## Product Change Notice (PCN)

PCN Number: PCN-0454834R-01

Product(s) Affected: SJ2-35853B-SMT-TR, SJ2-35853A-SMT-TR

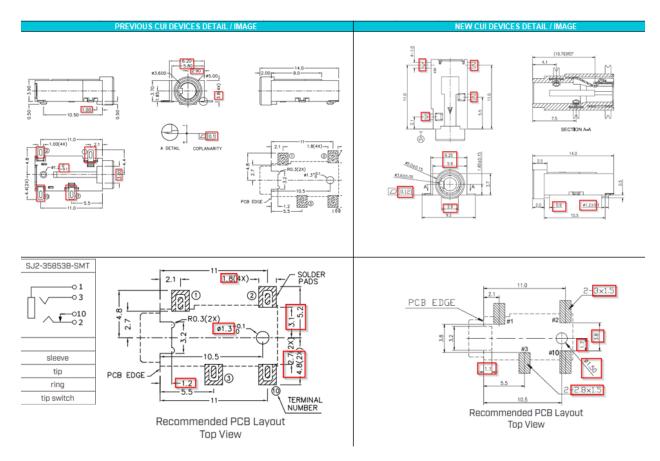
Description of Change: Mechanical, electrical, soldering, packaging, and material changes as shown below:

MATERIAL	PLATING	
terminal 1	copper alloy	silver	
terminal 2	copper alloy	silver	
terminal 3	copper alloy	silver	
terminal 10	brass	silver	
plastic	PA10T

DESCRIPTION	MATERIAL	PLATING/COLOR
terminal 1	copper alloy t=0.20	nickel-silver
terminal 2	copper alloy t=0.25	nickel-silver
terminal 3	copper alloy t=0.20	nickel-silver
terminal 10	copper alloy t=0.20	nickel-silver
housing	PA9T (UL94V-0)	black
